Tom Nielsen
Development Manager
Coppabella Wind Farm Pty Ltd

Clarification on Rotor Swept Area

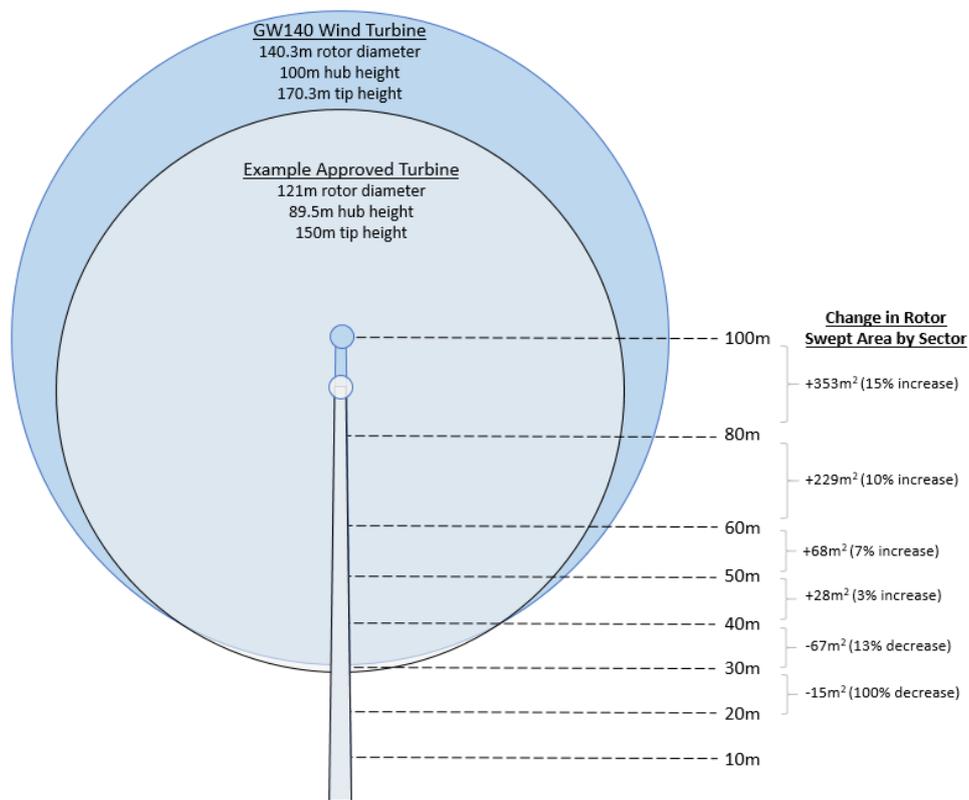
The IPC Panel raised a query on the basis for different percentage changes in rotor swept area (RSA) at different height sectors. By evaluating these height sectors individually, the potential impacts on bird species that frequent these heights can be better understood. As is noted in the BLA 2018 report, studies from eleven wind farms in south-eastern Australia reported that "the percentage of birds observed below 40 metres was on average 96%".

For the assessment of swept area changes at the different height sectors, approved wind turbine configuration (B) was utilised as the basis for comparison. This represents the combination of the largest rotor and highest tip height possible under the original approval. For a visual representation, of the changes in RSA at various heights, see below.

These calculations are captured in Table 3 of the BLA 2018 report:

The report also notes that if the modified wind turbine was compared against configuration (A) as introduced earlier (which has the largest approved rotor and lowest approved RSA height), then the increase in the lower swept height ground clearance of the modified wind turbine (from 17.5m to 30m) would result in less risk to 20% of all bird flights between 20-30m.

Figure 2. Preliminary Assessment Tool 1 indicating potential visual impacts for further detailed consideration

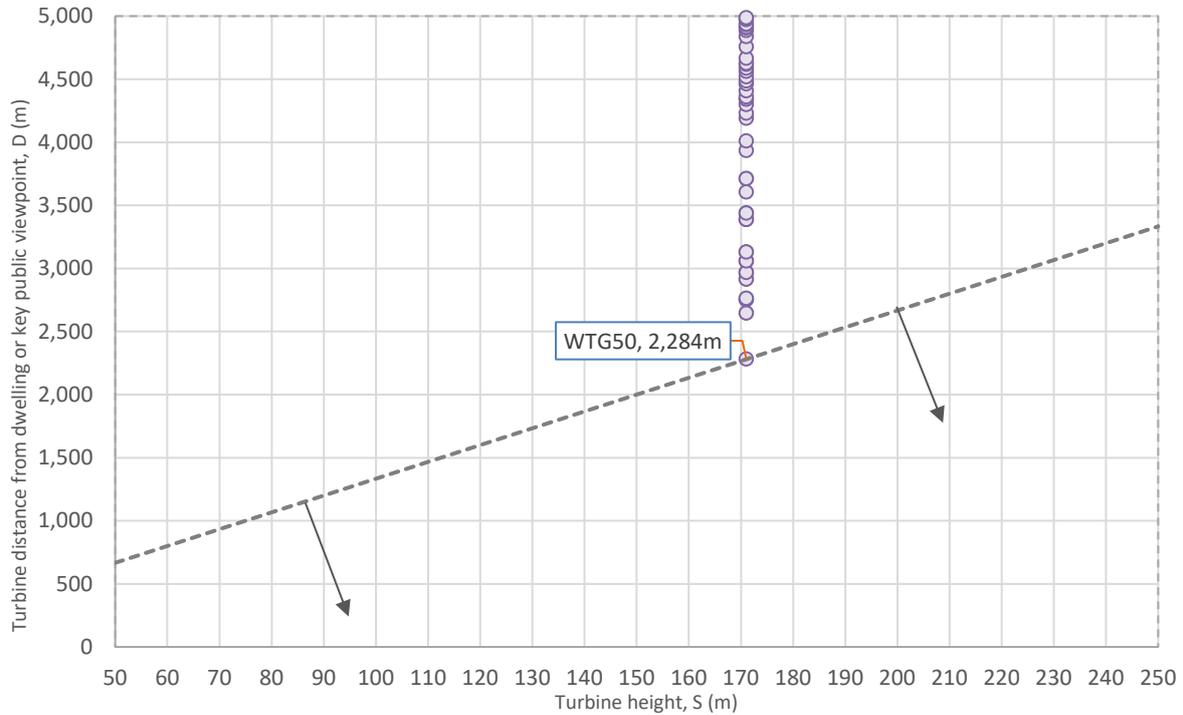
It was raised by the panel that Co4 may fall below the line on the distance tool contained within the NSW Wind Energy: Visual Assessment Bulletin. For a 171m tip height, the line on the distance tool indicates a 2,280m distance limit for warranting further consideration. The approved wind turbine location for WTG 50 is located 2,284 from Co4, and thus it is acknowledged that this residence falls very close to this line. For reference, the wind turbines within 5km of Co4 have been added onto the distance tool chart on the following page.

There has been some ambiguity around how to apply the Visual Assessment Bulletin to project modifications; as the bulletin sets out preliminary assessment tools primarily intended for the siting of new wind turbines. For this project, while the bulletin has been considered, the Visual Impact Assessment has focused on the change of impacts to nearby residences when comparing the modified and approved project dimensions. For Co4, there was no change in impact rating, and only two additional turbine blade tips would be visible across the project as a result of the increased turbine dimensions. The property was originally being considered as a host landowner for the original Yass Valley Wind Farm with turbines originally proposed to be located on the large hills to the North of the residence. These turbines were subsequently removed which has resulted in the hills (without turbines) now providing substantial screening from the turbines directly to the North.

The Visual Impact Assessment concluded that the wind farm modification would not introduce elements that are any more prominent or out of character with the approved Coppabella Wind Farm project, and that the modifications would result in an overall low-level change in visibility and a largely unchanged visual impact rating to that of the approved project.
